CITY OF LA VISTA
MAYOR AND CITY COUNCIL REPORT
OCTOBER 15, 2019 AGENDA

Subject:	Type:	Submitted By:
APPLICATION FOR PUD SITE PLAN – LOTS 19-20, SOUTHPORT WEST & LOTS 2-3 SOUTHPORT WEST REPLAT 2 (NW OF WESTPORT PKWY)	◆ RESOLUTION ORDINANCE RECEIVE/FILE	CHRISTOPHER SOLBERG SENIOR PLANNER

CASE NUMBER: PPUD-19-0001

RE: Planned Unit Development (PUD) Amendment
Initial Review
Brixmor North – Southport West

SHEET
C.1.1

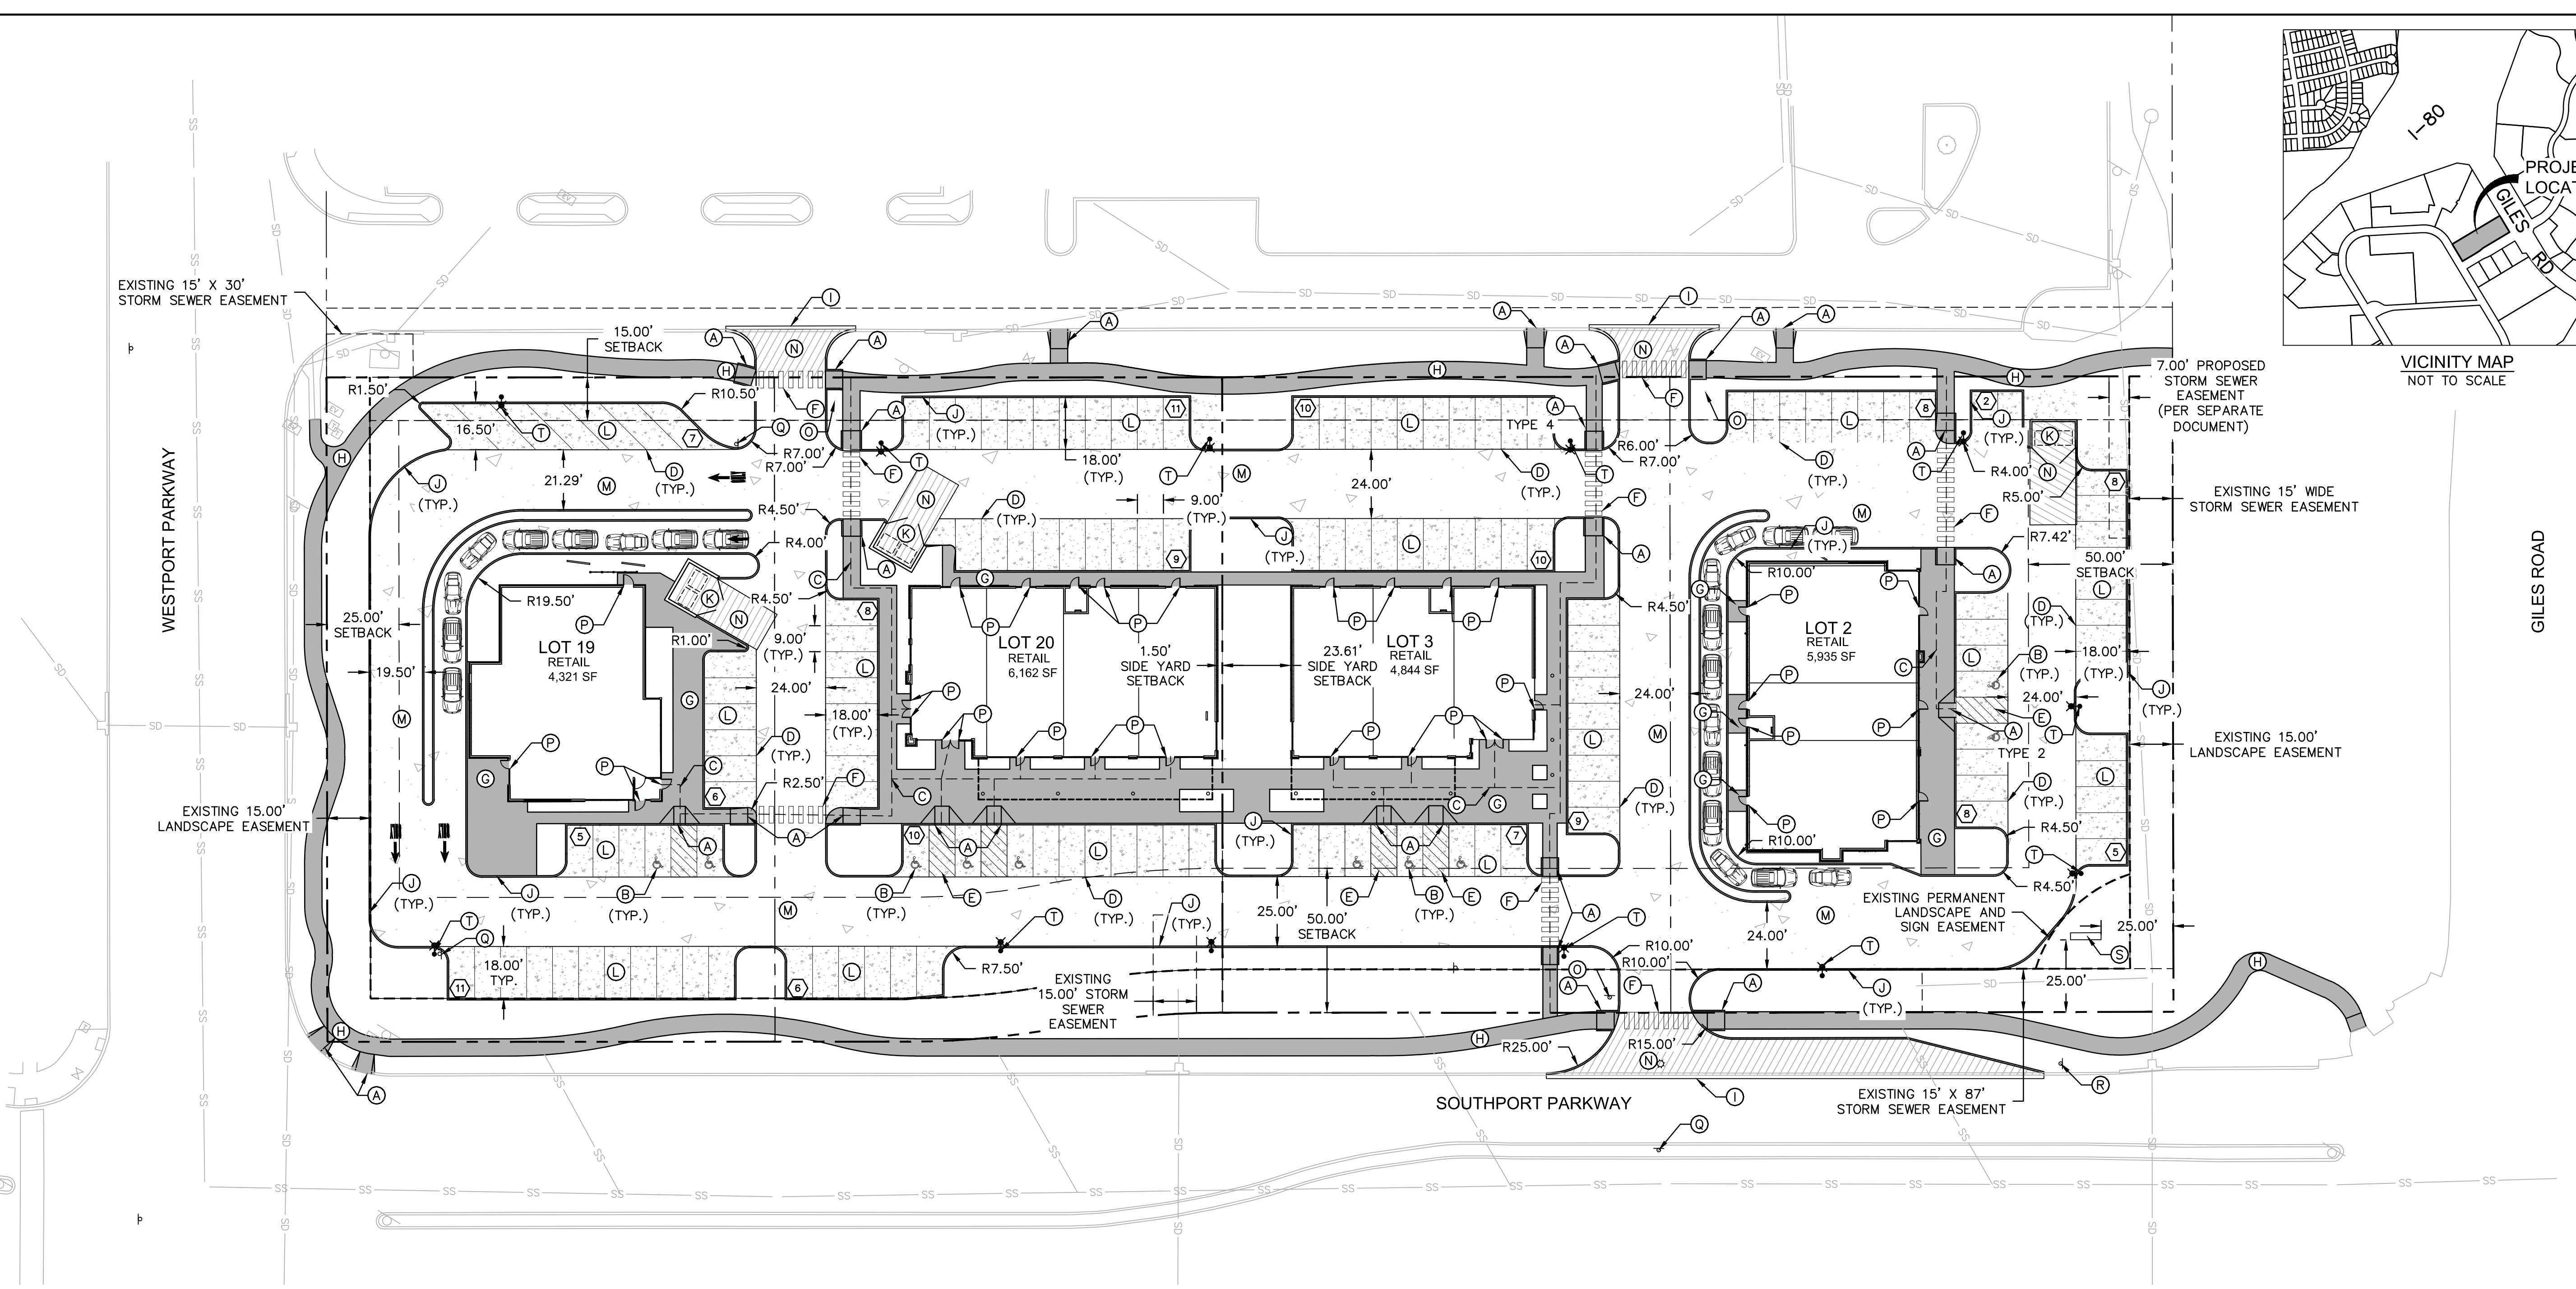
- The existing storm sewer and landscaping easements from the existing previous plats need to be noted.
- Any removals of existing infrastructure or landscaping should be noted on this sheet.

- The RIRO access change will most likely need to be done through a replatting process as existing plats show a right in only access at the between lots 20 and 3 Per Southport West Replat 2. Replatting could also adjust the boundaries between lot 20 and 3 and perhaps address any setback and/or fire code issues, as well as add notation for the RIRO access.

- The existing storm sewer and landscaping easements from the existing previous plats need to be noted. **Response: This has been added to the plan.**
- Any removals of existing infrastructure or landscaping should be noted on this sheet. **Response: Removals have been added to the plans.**
- The RIRO access change will most likely need to be done through a replatting process as existing plats show a right in only access at the between lots 20 and 3 Per Southport West Replat 2. Replatting could also adjust the boundaries between lot 20 and 3 and perhaps address any setback and/or fire code issues, as well as add notation for the RIRO access. **Response: Understood. Follow up discussion is needed to determine what is requested for this replat.**

SHEET
C3.1

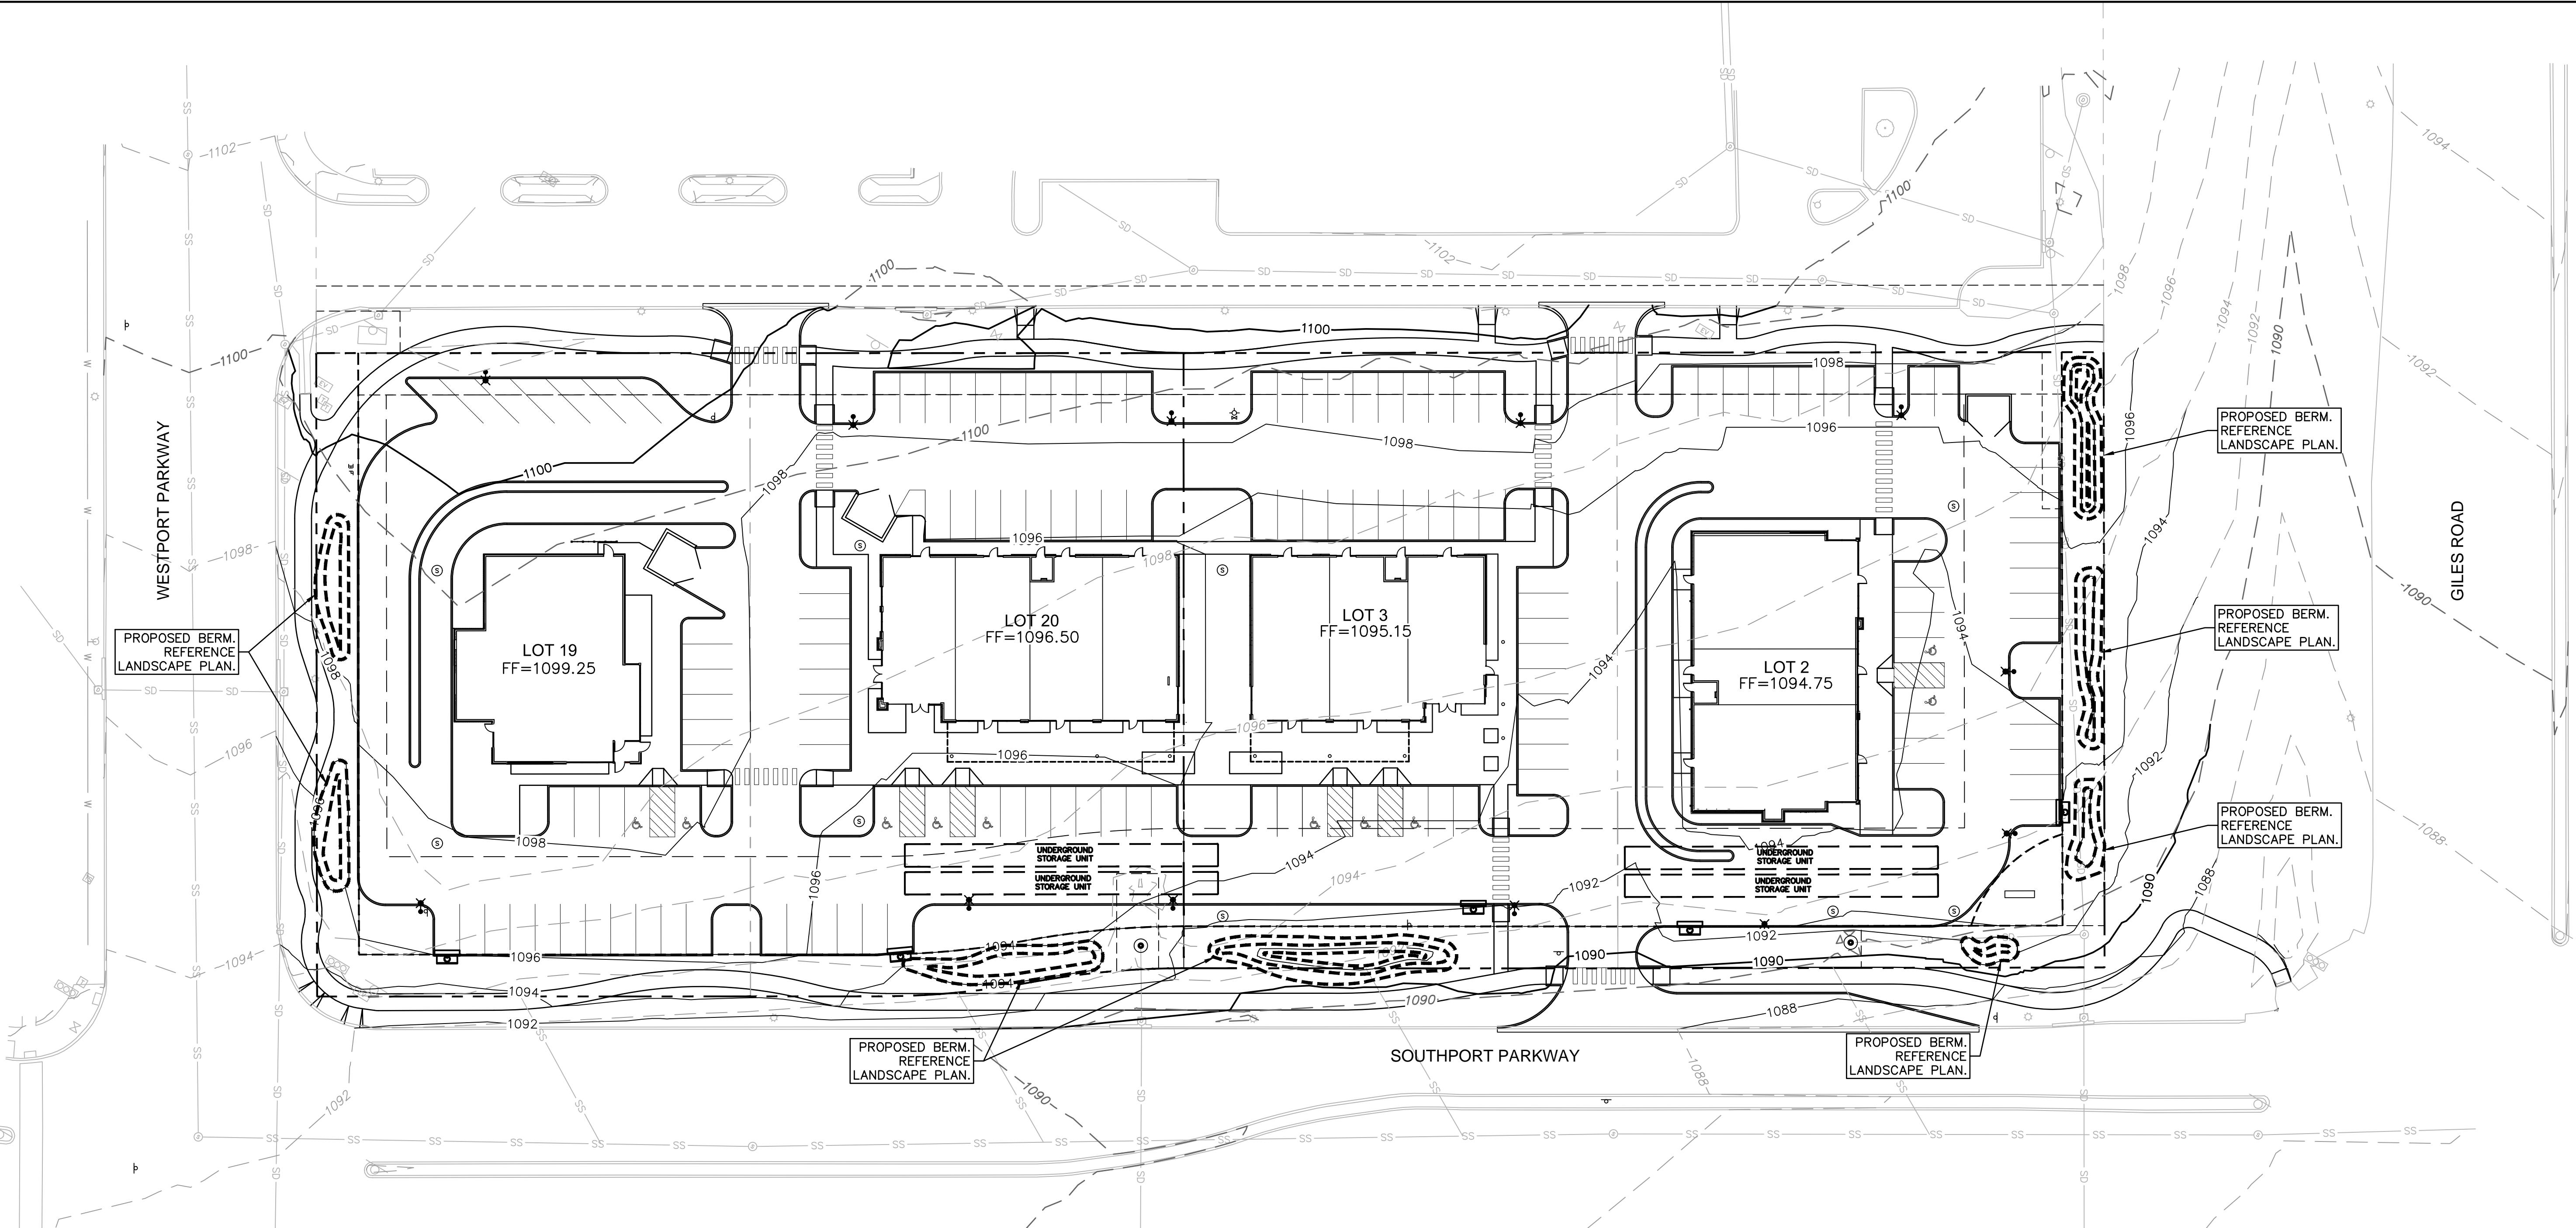
- Grading work will require a grading permit. Refer to the Master Fee Ordinance for details.
- Grading plan needs to address a conceptual design of water quality and 2-year peak flow detention, such as indication of bio-basins or under parking lot facilities.
- As there are drainage capacity limitations at the culvert crossing near under the rail road southeast of Giles road, all catchments drain that drain into said basin should be held to a no-net increase of the predevelopment flows until the drainage culverts at the railroad is up-sized to account for post-developed conditions for a 100-year return frequency.
- The grading plan submitted does not depict the required berthing of the landscaped areas along Westport Parkway as required per Section 8(B)(ii)(c) of the Southport West PUD.

- Although the engineering consultant's response letter notes adjustments to the grading plan in relation to the berthing required as per Section 8(B)(ii)(c) of the Southport West PUD, the PUD documents submitted do not sufficiently depict the required berthing.

- Although the engineering consultant's response letter notes adjustments to the grading plan in relation to the berthing required as per Section 8(B)(ii)(c) of the Southport West PUD, the PUD documents only depict berthing along Westport Parkway and the western half of Southport Parkway.

- Grading plan needs to address a conceptual design of water quality and 2-year peak flow detention, such as indication of bio-basins or under parking lot facilities. **Response: A water quality structure has been provided along with under parking storage to ensure we are not increasing the offsite flow.**

- The grading plan submitted does not depict the required berthing of the landscaped areas along Westport Parkway as required per Section 8(B)(ii)(c) of the Southport West PUD. **Response: Berthing has been added and noted on the plan.**
